3 March 2022  
Contact: Richard Seaward

Ref: WTJ22-024-MOD2

**SECTION 4.55(1A) MODIFICATION APPLICATION TO MODIFY SSD 10371  
TRINITY GRAMMAR SCHOOL  
119 PROSPECT ROAD AND 50-52 SEAVIEW STREET, SUMMER HILL  
LANDSCAPING AMENDMENT**

Figure 1: Extract from approved SSD landscape plans.

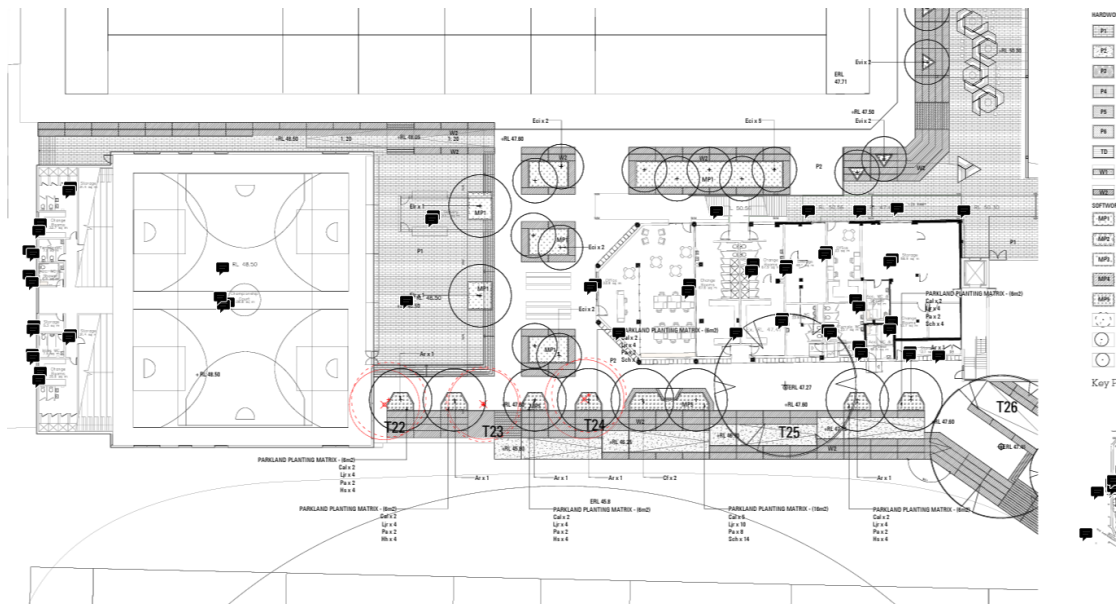
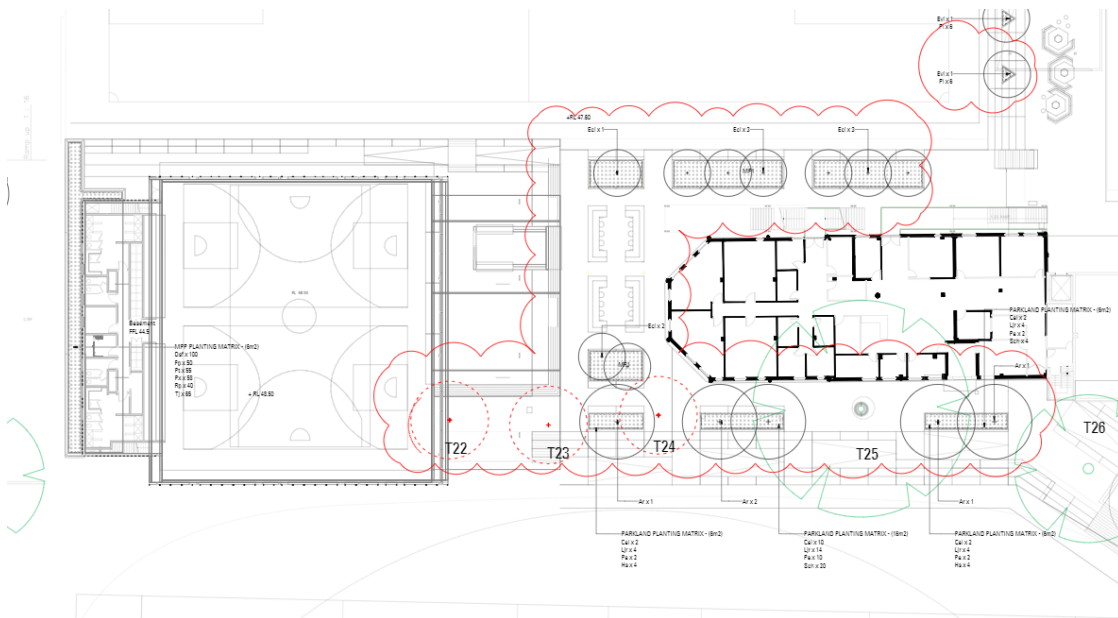
- Removal of two trees at the southern edge of Chapel Drive;
- Changes to tree planting locations along western boundary to Oval 2;
- Changes to tree planting locations to south-western boundary of the site (Oval 1); and
- Changes to tree planting locations along western boundary to Oval 3.

The figures below provide an overview of these changes to the landscape design.

Figure 5: Extract from approved SSD landscape plans.

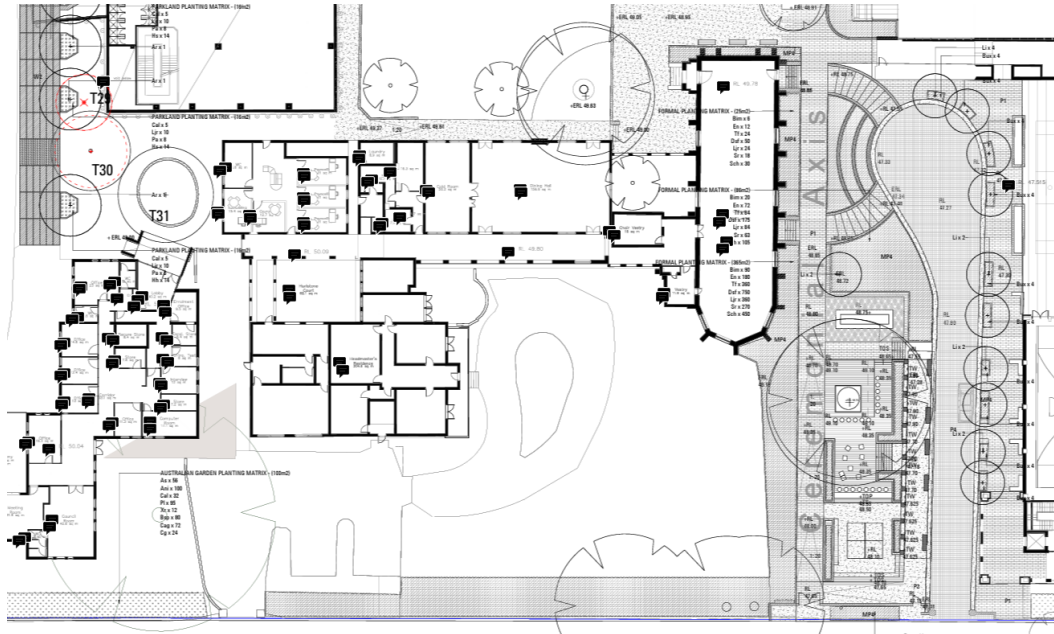
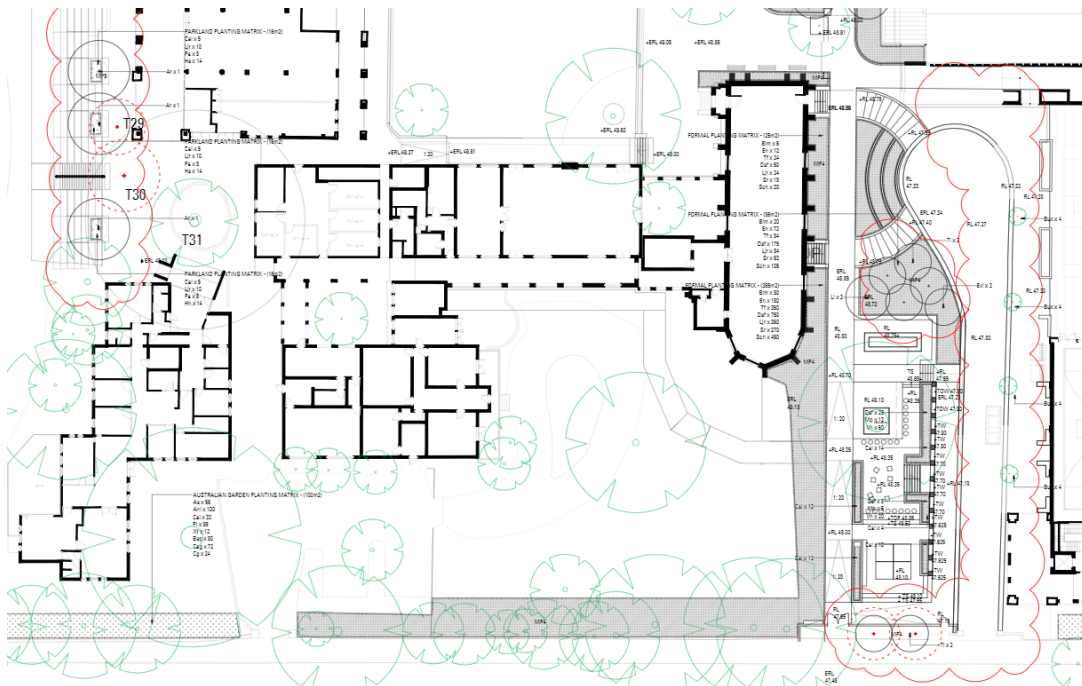
The proposed changes to the layout of planters framing the Music Building will be of minor nature and involve no direct impact to the significant heritage fabric noted within the subject site. The planter layout has been revised as part of the design development phase to better respond to the aesthetic language of the Trinity Theatre, bleacher terraces to the Jubilee Drive façade (west) and overall design of the landscape masterplan. As visible in Figures 1 and 2, these changes relate to the length, shape, positioning and number of proposed planters whilst maintaining a consistent overall distance between the landscape elements and the southern elevation of the music room. Some trees within the same space have also been repositioned to better suit planter soil volume capacities. These works will not involve any additional demolition and will have no additional impact on the established heritage significance of the site.
